Technical Preservation Services
Preservation Assistance Division
National Park Service
U.S. Department of the Interior
Washington, D.C.

Interpreting the Secretary of the Interior's Standards for Rehabilitation

Volume III

2. New floor plan after rehabilitation shows that although lightshaft has been eliminated, basic concept of "railroad flat" remains.

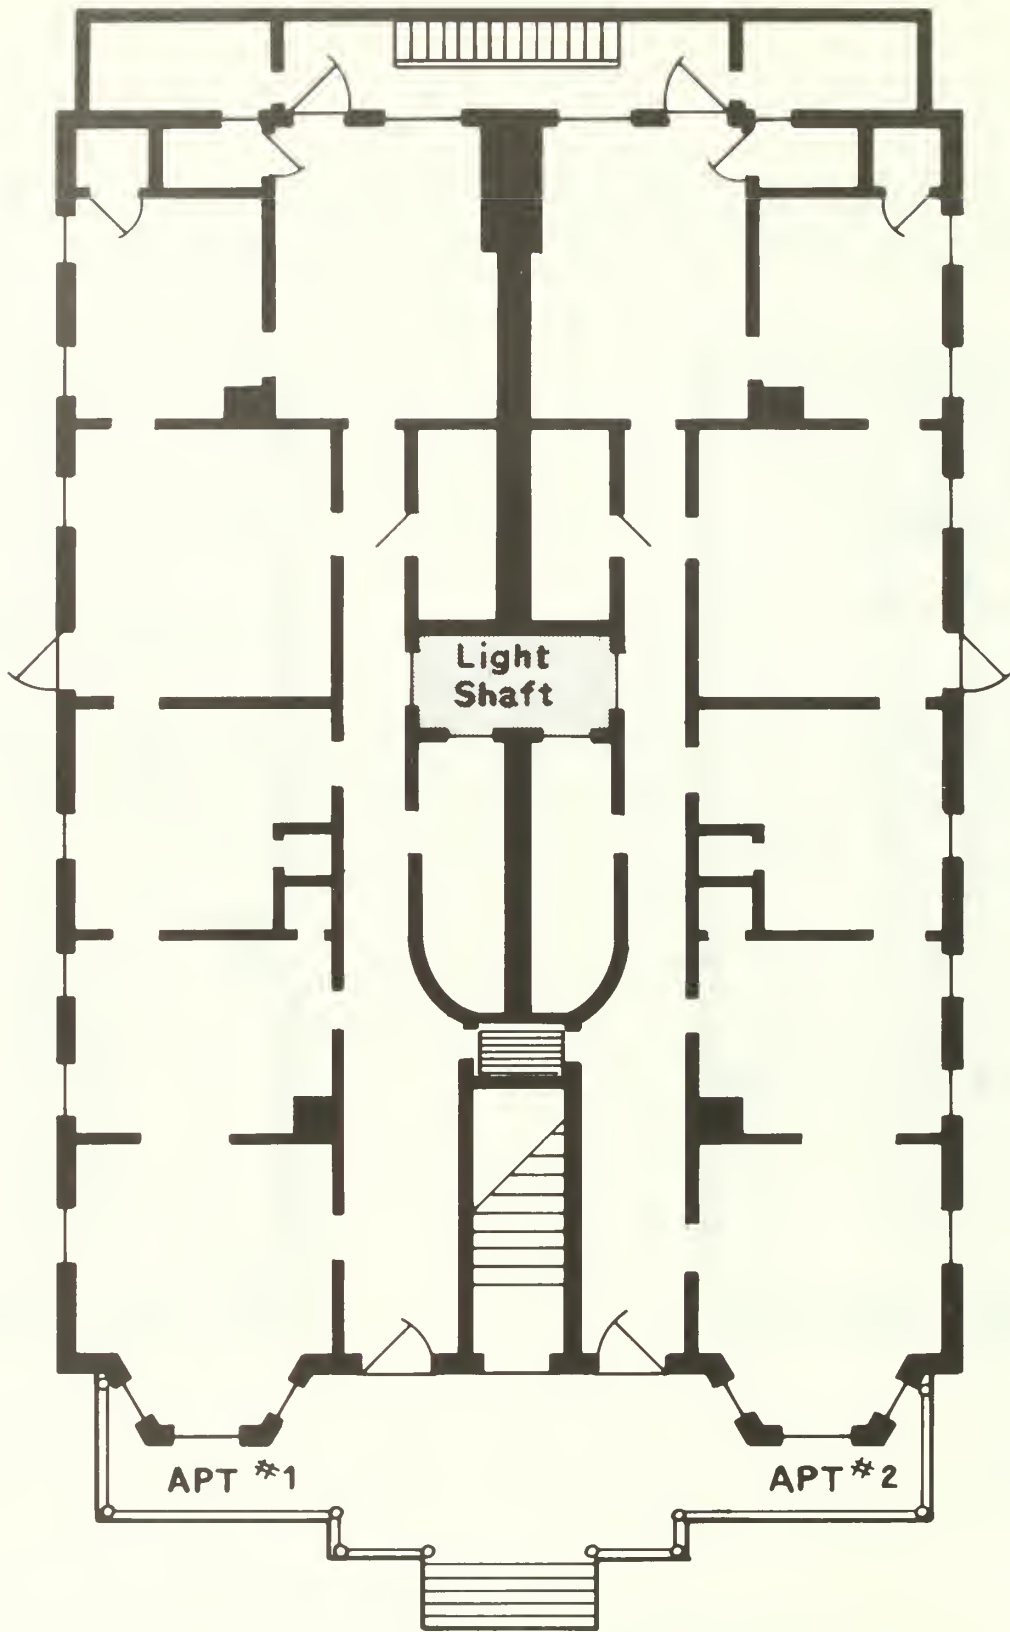
Application: A modest two-story, turn-of-the-century rowhouse which was built in 1902 originally as working-class housing, contained four "railroad" flats, two on each floor separated by a center vestibule and stair, and a lightshaft in the rear (see illus. 1). Rehabilitation plans appropriately called for the retention of the four units. However, although the basic "railroad" plans were retained for each flat (despite some relatively minor changes), rehabilitation did result in the elimination of a narrow (approximately three feet) enclosed light shaft which separated the two sets of flats (see illus. 2). The National Park Service acknowledged that the narrow light shaft had lost its function and did not meet minimum standards for light and air, but noted that this alone did not justify its removal since Department of the Interior regulations state that "the Standards take precedence over other regulations and codes in determining whether the historic character of the building is preserved in the process of rehabilitation. . ." Thus, the necessity of meeting health and safety code requirements is not a factor taken into consideration by the National Park Service in its review of a rehabilitation project. More importantly, the National Park Service determined that obliteration of the lightshaft did not result in significant changes to the floor plan, nor did it alter the character-defining features of the exterior. The "exterior continues to contribute to the significance of the historic district in which it is located, and the interior still preserves its original center-entrance plan." In short, the rehabilitation was determined to be in conformance with the Standards because "those components that are important in defining its character have been retained."

5. After rehabilitation floor plan of 1900 building.

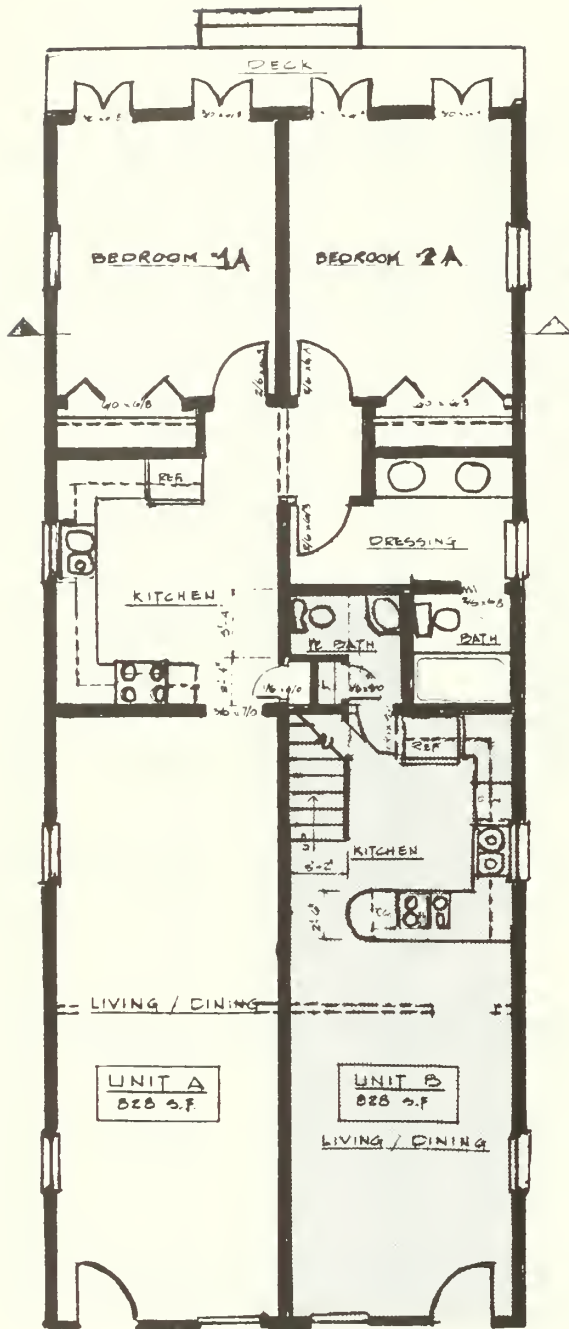
In the first case, the "shotgun" plan was generally retained in the rehabilitation with some modifications (see illus. 5). Kitchens were inserted into the second room of each half of the duplex; a bathroom and laundry were inserted into the third room. The fourth room in each half of the building was enlarged by moving the partition forward a few feet. Despite these alterations, the division of the building into two equal units was respected in the rehabilitation. Within each half of the double cottage, the interior arrangement of small rooms, one behind the other, was also maintained. Thus, on both the exterior and the interior, the building appears as it appeared historically, as a modest double cottage in the "shotgun" style. This plan largely determined its historic character, which remains following the rehabilitation. The project meets the "Standards for Rehabilitation."

6a and 6b. After rehabilitation floor plan of 1890 building. The unit on the left now extends across the full width of the building in the rear half. To regain the floor space thus lost in the right unit, a stair was added, further altering the plan of this simple structure.

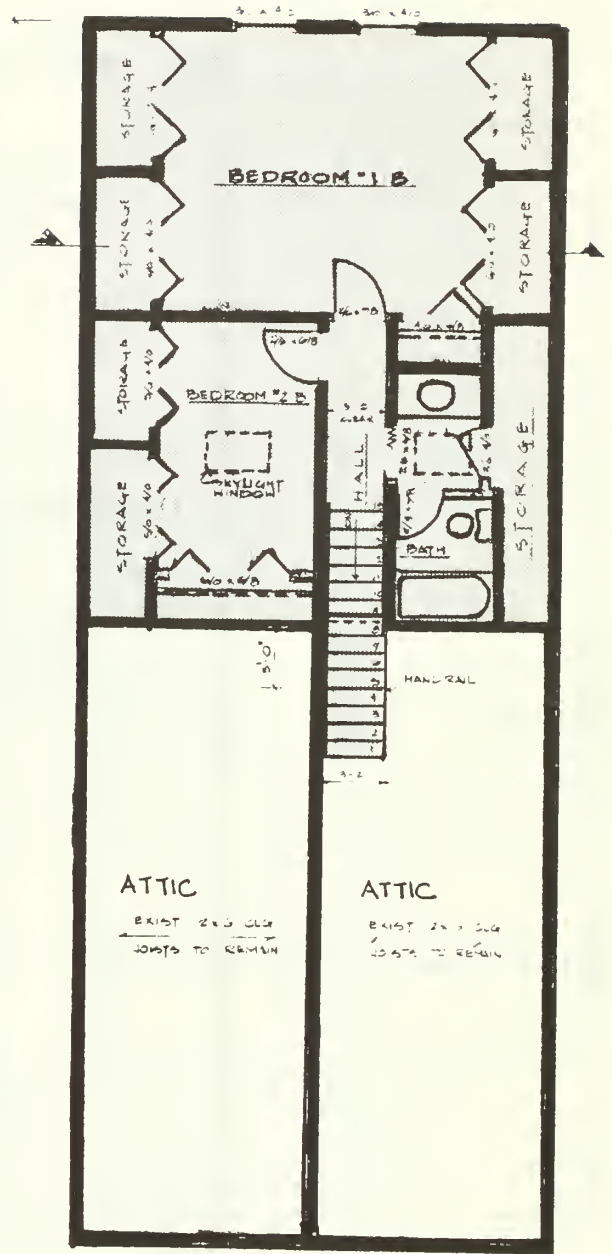
In the second case, radical changes made during the rehabilitation obliterated the characteristic interior plan (see illus. 6). The separation between the two front rooms was destroyed to create one larger room in place of the double parlor arrangement. In

order to enlarge the apartments, the plan was further altered by incorporating almost the entire rear half of the right unit into the left unit. The floor space lost to the right unit was regained through the addition of a stair to the attic, into which two bedrooms were added. In this project the damage done to the historic character of this modest building is extreme. The units no longer convey a sense of the original "shotgun" plan. Construction of the stair in the right unit has further drastically altered the structure by introducing a vertical element missing from the historic plan. Finally, the division between the halves of the building was effectively destroyed in the rear half of the building. Accordingly, the project fails to meet the Secretary of the Interior's "Standards for Rehabilitation."

5. Lobby and adjoining spaces after rehabilitation. The palm room and dining room have been subdivided. A new partition directly behind the decorative screen has destroyed the progression of spaces that marked the original design.

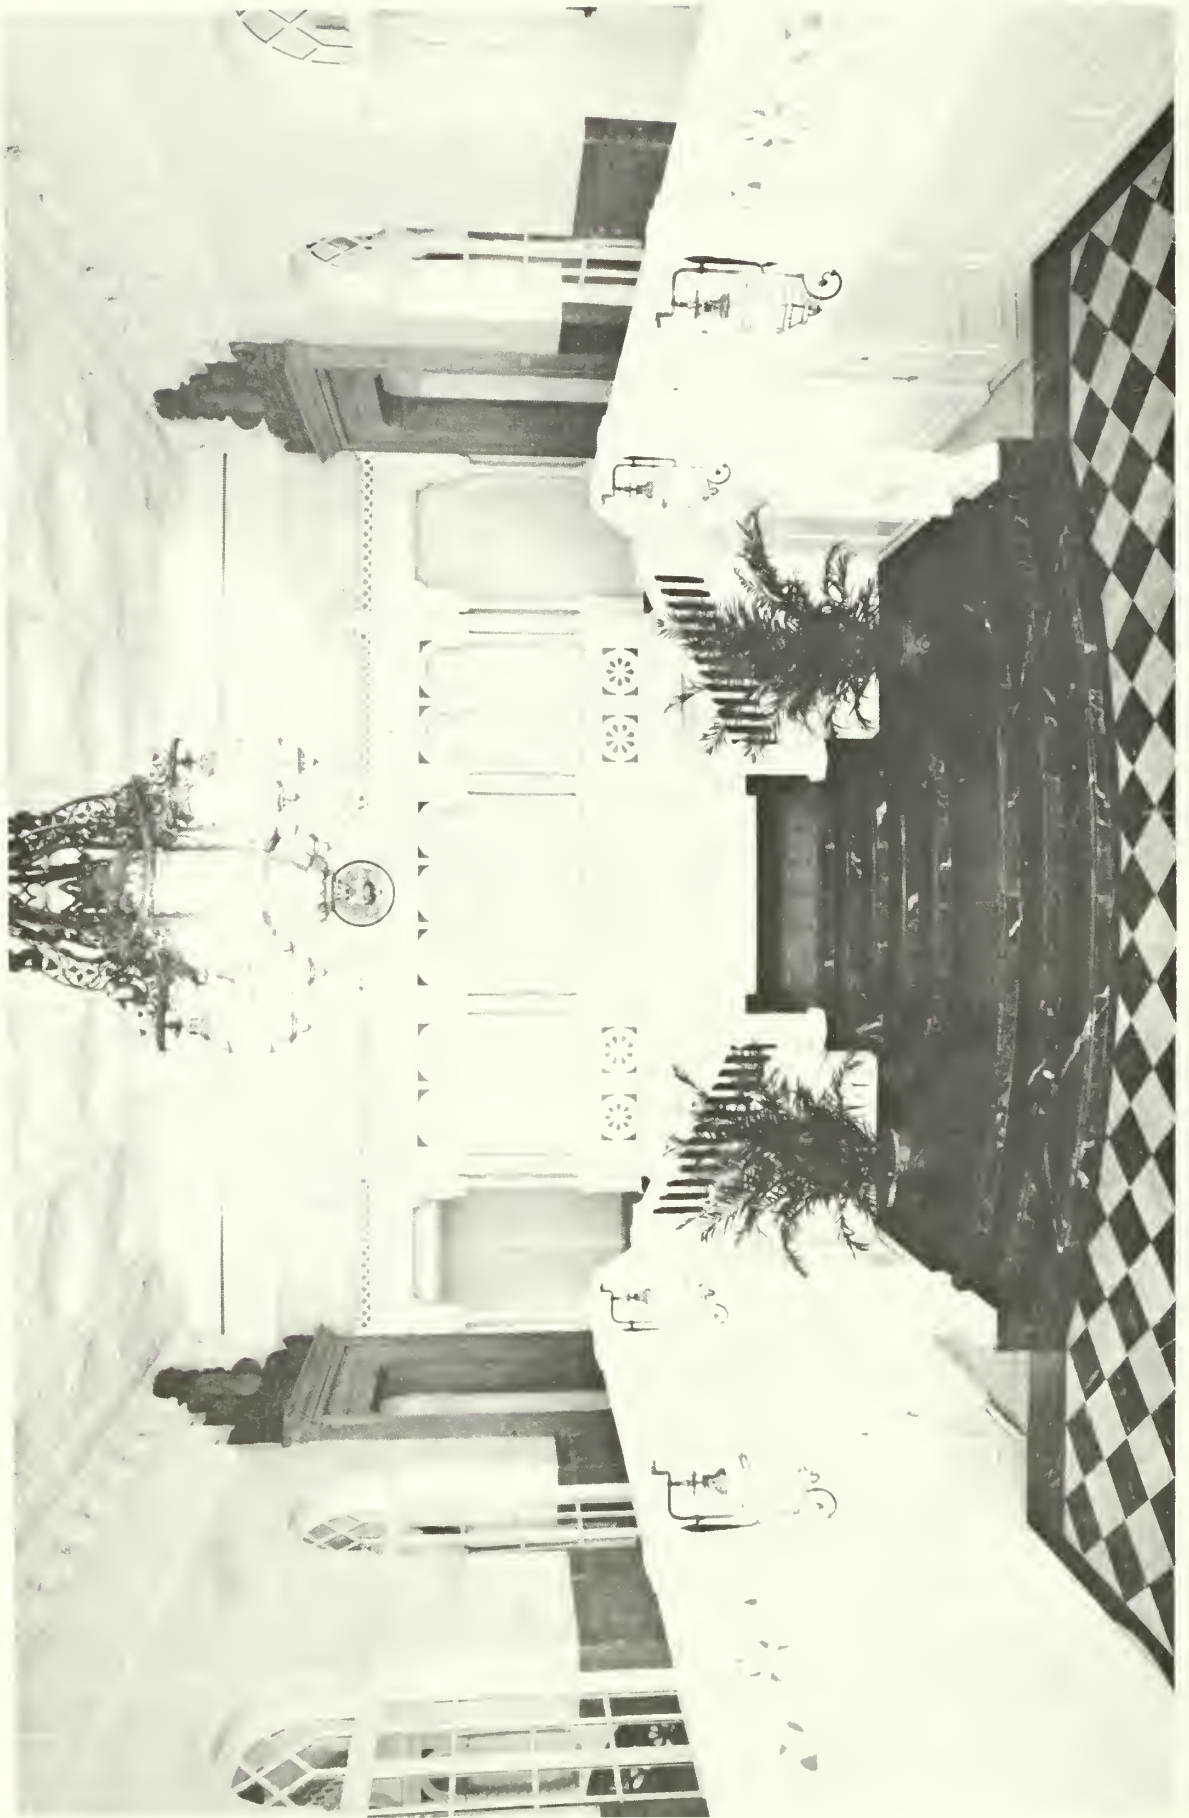
The insertion of a solid partition behind the open screen effectively cut off the lobby from the palm room. The damage wrought by the rehabilitation to the individual spaces thus exceeded the demolition of individual features or their incorporation into smaller rooms. The rehabilitation destroyed the formal organization of the spaces themselves. The progression from the grand, three-story lobby, up the elaborate split stair into the palm room and adjoining dining room was lost, and the historic character of the building irreparably harmed.

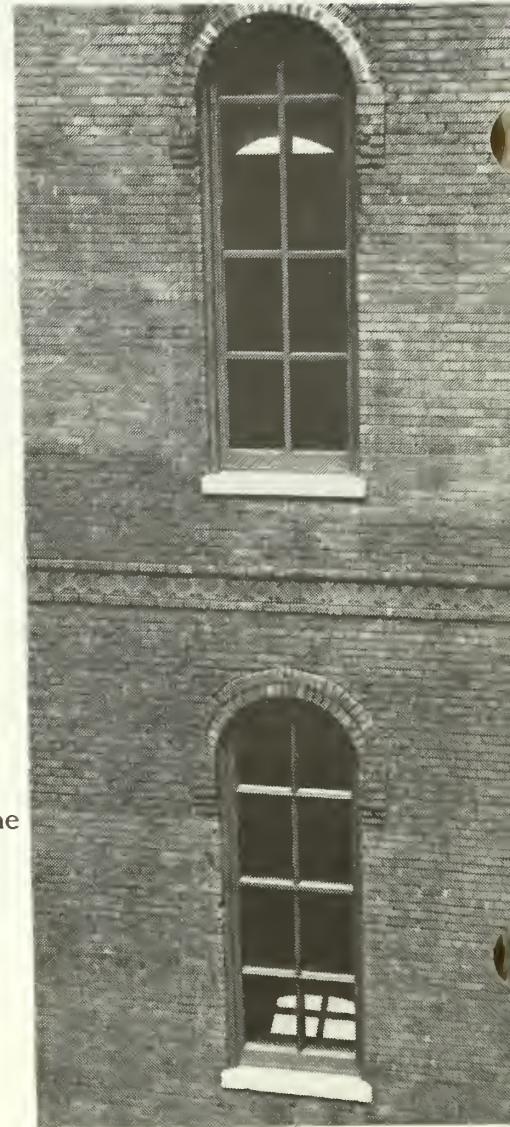
Before and after photographs revealed several design deficiencies in the new window. Where one over one double-hung windows had existed historically on the building's primary facade, the replacement windows were a "fixed" design with both upper and lower sash on the same plane; the horizontal piece applied as a meeting rail is actually flat, and consequently unable to cast the familiar shadow line of the historic window. Finally, there was a dramatic difference in color, from a light cream color to dark brown (see illus. 1 and 2). On another key facade, where there had been historic four-over-four double-hung windows, fixed sash were installed, the light divisions were altered, wider muntins were used, and the color of the windows was changed (see illus. 3, 4 and 5).

4 and 5. After rehabilitation, there is a striking change in the appearance of the entire facade due to the installation of inappropriate replacement windows. In addition to the obvious color disparity, the unit is noticeably on one plane rather than double-hung. The muntins are also much heavier and there is no meeting rail.

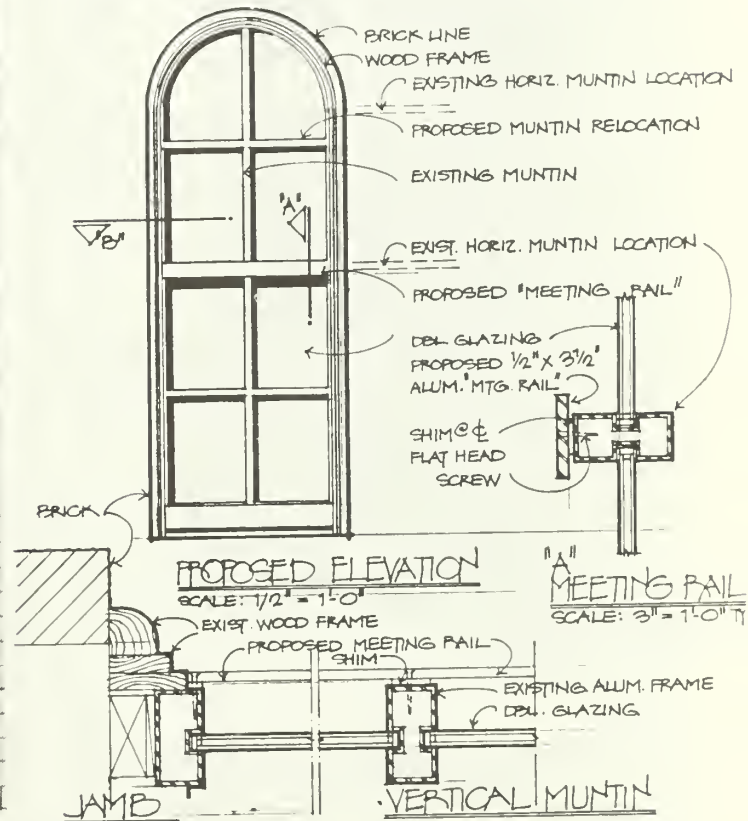
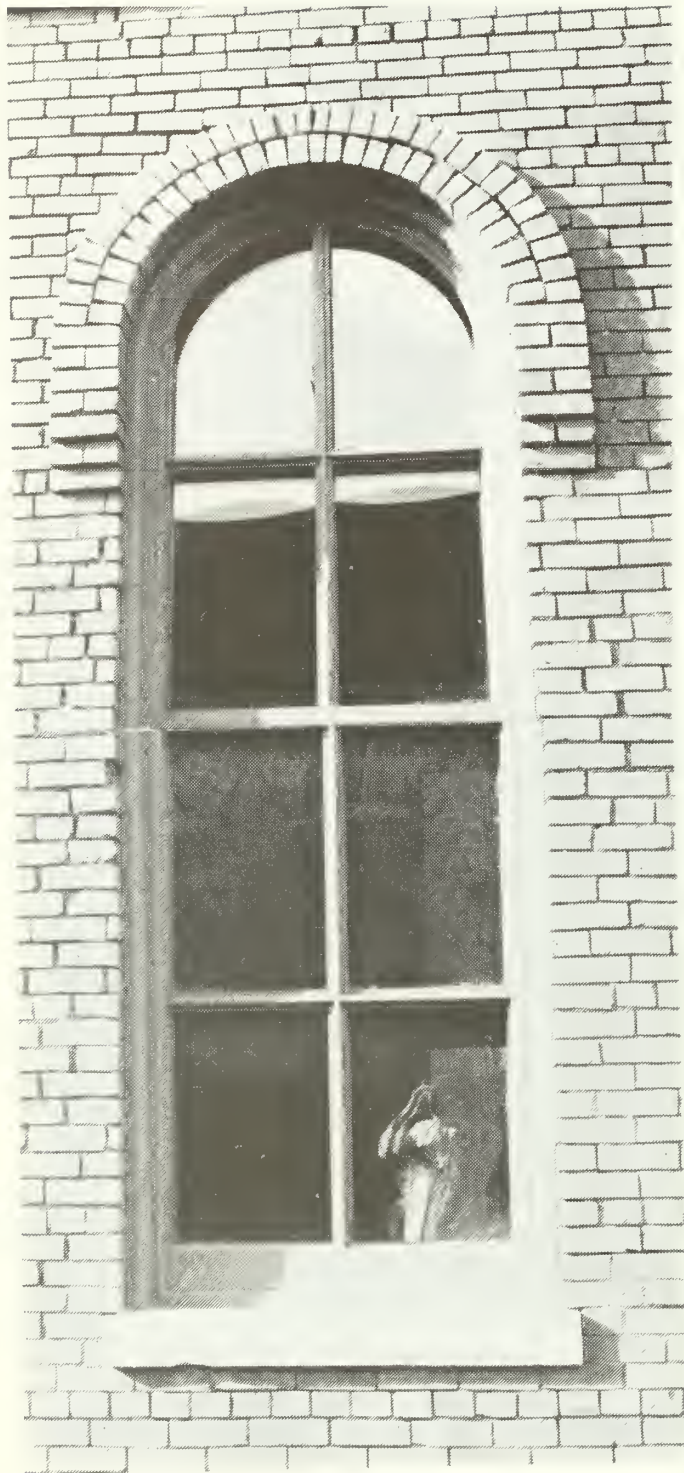
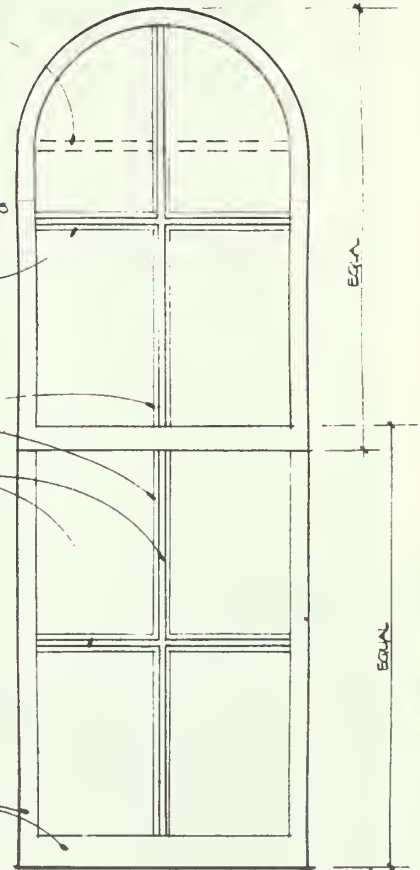
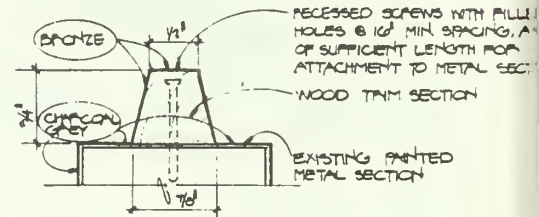
6. In an attempt to bring the inappropriate four-over-four replacement units (see 4 and 5.) into conformance with the Standards, two alternatives were proposed. In proposal A, the horizontal muntin at the top would be relocated so that all eight lights would be of equal size like the original. A 3 1/2" wide aluminum strip would be applied in an attempt to recapture some aspects of the meeting rail. Even after these adjustments, however, the upper and lower sash would read as a single, fixed unit; the muntins are also too wide and too flat.

REMOVE TOP HORIZONTAL MUNTIN & GLASS

APPLY WOOD TRIM SECTION TO PAINTED MUNTINS

APPLY 3/4" THICK x FULL WIDTH (OF EXISTING SECTION) WOOD SECTIONS TO HORIZONTAL & VERTICAL PERIMETER SECTIONS & TO HORIZONTAL MEETING PAL COLOR TO BE BRONZE

6. Shop drawing showing applied muntin grid projecting beyond the exterior surface of the sash. Also note rectangular shape and the two grooves on the interior and exterior muntin grids which produce the ribbed appearance and additional shadow lines that did not exist on the historic windows.

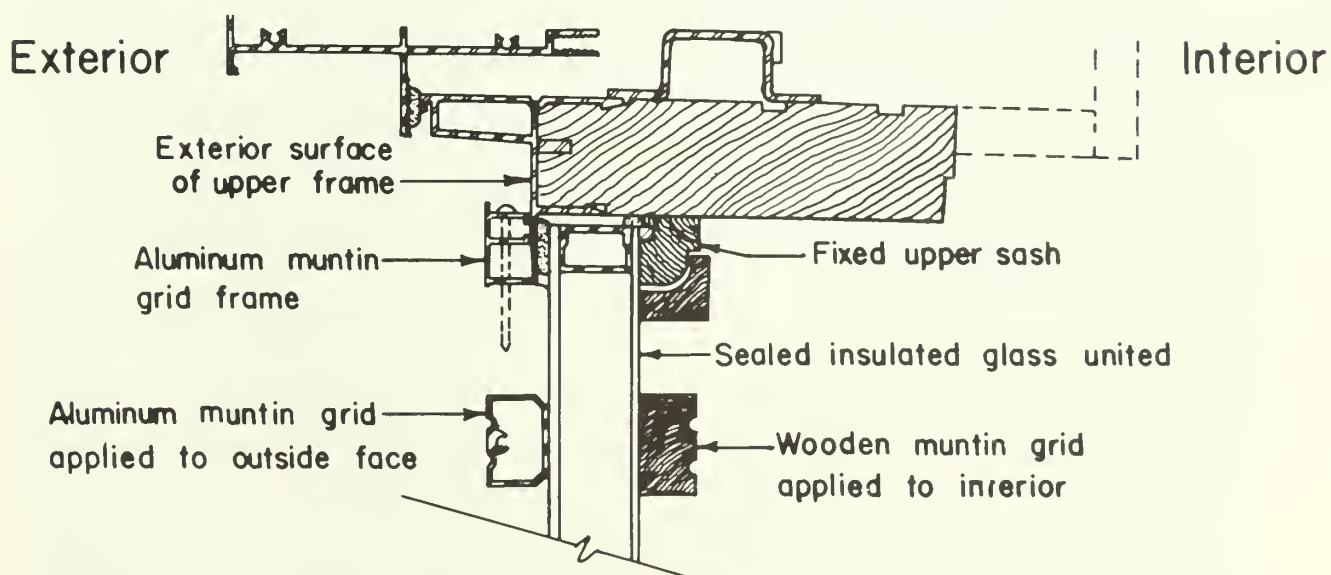
The thickness of the meeting rail so evident in the historic sash has been reduced in depth creating a weaker shadow line (see illus. 5). The use of an applied aluminum muntin grid rather than true 16-over-16 wood muntin divisions has caused significant changes to the appearance of the windows (see illus. 6). The muntin grid clearly does not match the original, since the new muntins have a rectangular rather than trapezoidal profile, it has a ribbed surface, and it extends beyond the plane of the rails and stiles. The projecting grid, furthermore, creates additional shadow lines that did not exist on the historic windows. The historic muntins were flush to the surface of the sash, integral to the sash frame construction and trapezoidal in shape after puttying.
